**Service Bulletin No:** 21-006  
**Modification No:** EC-19-0747

**ENVIRONMENTAL CONTROL - LIQUID/GAS COOLANT  
REPLACEMENT OF THE COCKPIT AND CABIN EVAPORATOR FILTERS**

Replacement of the evaporator filter assembly - Cockpit  
Figure 1 (Pre and Post Service Bulletin)

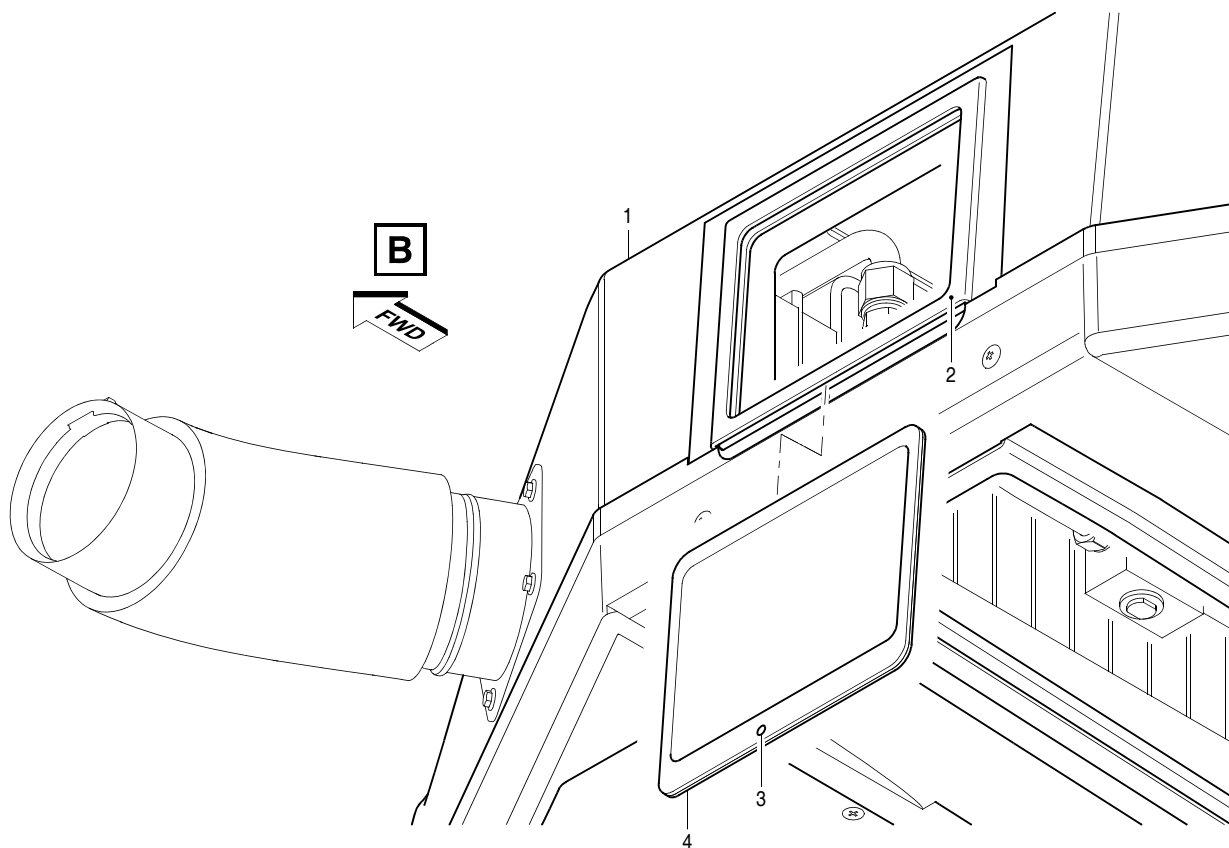
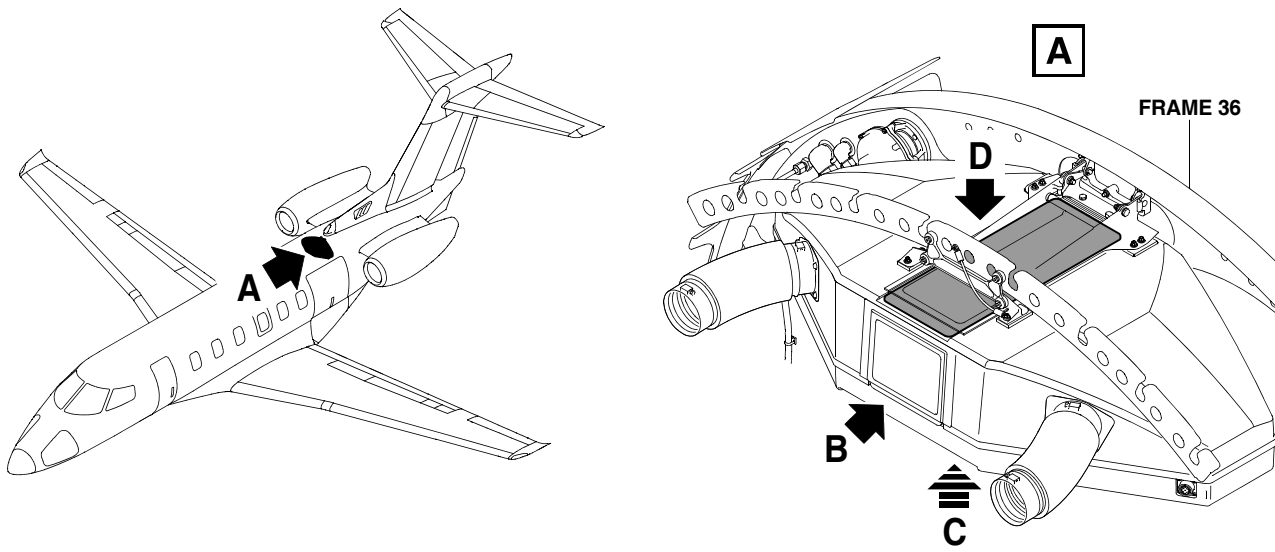
The supplier of the cockpit and cabin evaporator filter assemblies has informed Pilatus of a quality escape with their evaporator filter material. Configuration control issues resulted in filters with degraded fire retardant properties being supplied in error.

Replace the cockpit and cabin evaporator filters with the new filters that are made from a different material.

**B. Modification****(1) Cockpit evaporator - Replacement of the filter assembly. Refer to Figure 1**

- (a) Disengage the retention rivet (4) that safeties the filter assembly, cockpit (1) on the cockpit evaporator (2).
- (b) Pull the existing filter assembly, cockpit (1) out of the retention rails (3) and discard.
- (c) Push the new filter assembly, cockpit (1) (Pilatus P/N 959.90.20.303) (Supplier P/N PC24EC-6068-5) into the retention rails (3).
- (d) Safety the filter assembly, cockpit (1) in position with the retention rivet (4).

Replacement of the evaporator filter assemblies - Cabin  
Figure 2 (Sheet 1 of 2) (Pre and Post Service Bulletin)

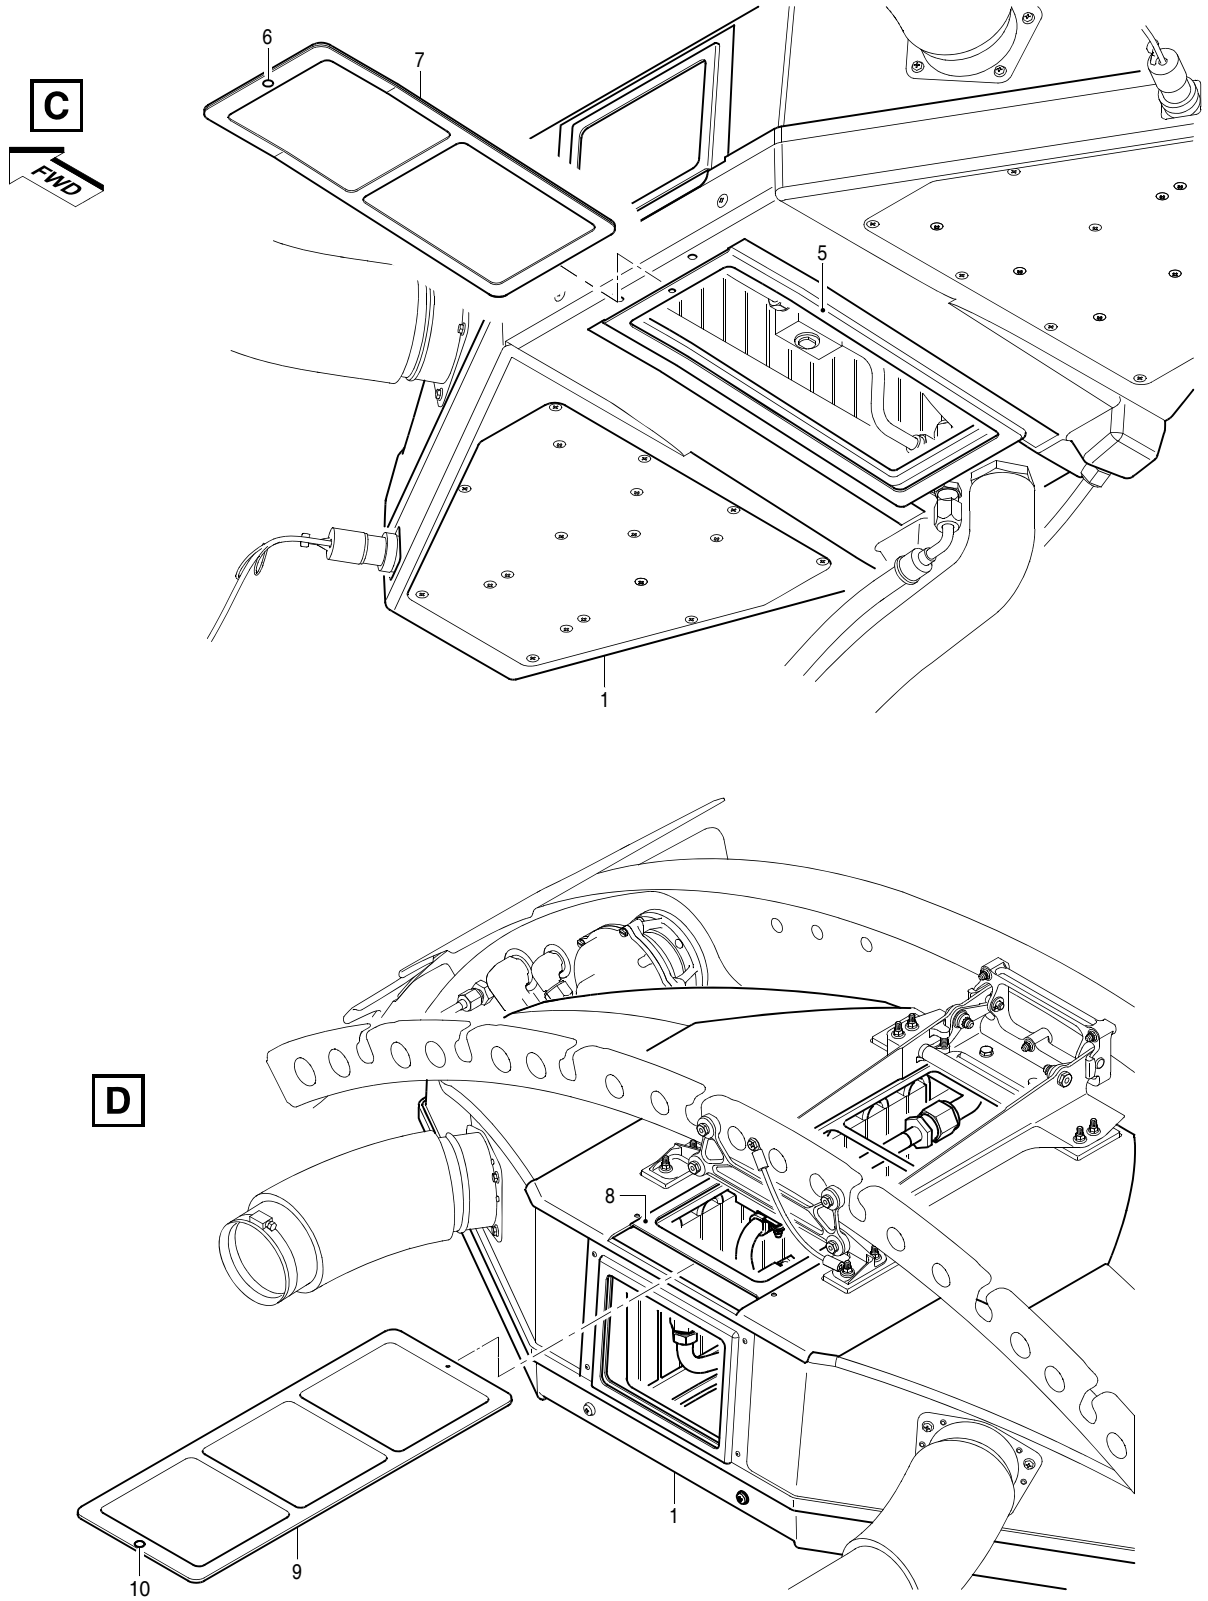
**(2) Cabin evaporator - Replacement of the filter assemblies. Refer to Figure 2**

- (a) Disengage the retention rivet (3) that safeties the filter assembly, front (4) on the cabin evaporator (1).
- (b) Pull the filter assembly, front (4) out of the retention rails (2) and discard.

- (c) Disengage the retention rivet (6) that safeties the filter assembly, bottom (7) on the cabin evaporator (1).
- (d) Pull the filter assembly, bottom (7) out of the retention rails (5) and discard.

- (e) Disengage the retention rivet (10) that safeties the filter assembly, top (9) on the cabin evaporator (1).
- (f) Pull the filter assembly, top (9) out of the retention rails (8) and discard.

- (g) Push the new filter assembly, top (9) (Pilatus P/N 959.90.20.306) (Supplier P/N PC24EC-6297-5) fully into the retention rails (8).
- (h) Safety the filter assembly, top (9) in position with the retention rivet (10).

- (i) Push the new filter assembly, bottom (7) (Pilatus P/N 959.90.20.305) (Supplier P/N PC24EC-6288-5) fully into the retention rails (5).
- (j) Safety the filter assembly, bottom (7) in position with the retention rivet (6).

- (k) Push the new filter assembly, front (4) (Pilatus P/N 959.90.20.304) (Supplier P/N PC24EC-6287-5) fully into the retention rails (2).
- (l) Safety the filter assembly, front (4) in position with the retention rivet (3).
